SERVICE INSTRUCTION

Oil Pressure Sensors for ROTAX® Engine Type 912 and 914 Series

ATA System: 79-20-00 Oil pump assy.

Fig. 5

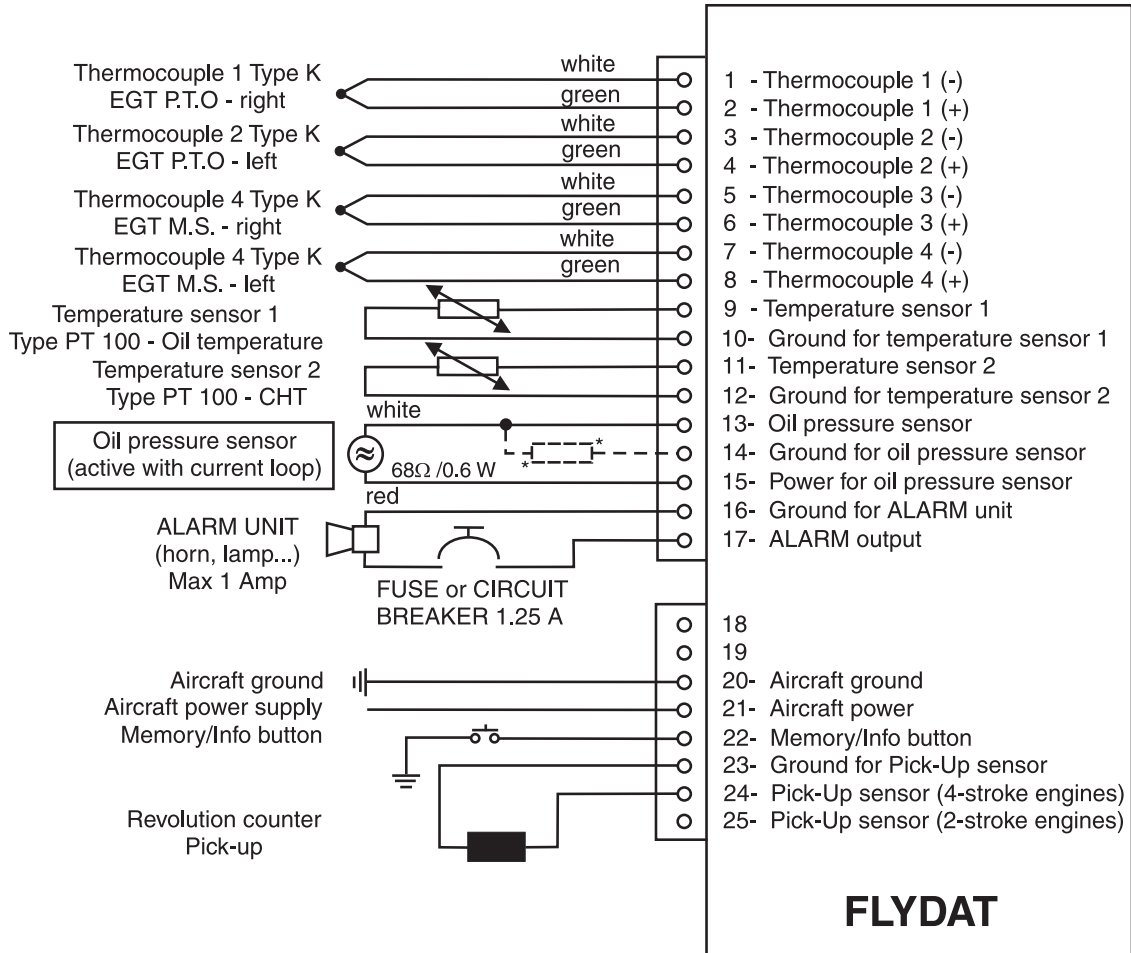
* resistor is part of the retrofit kit for Flydat part no. 886857. See also 1.3.2.
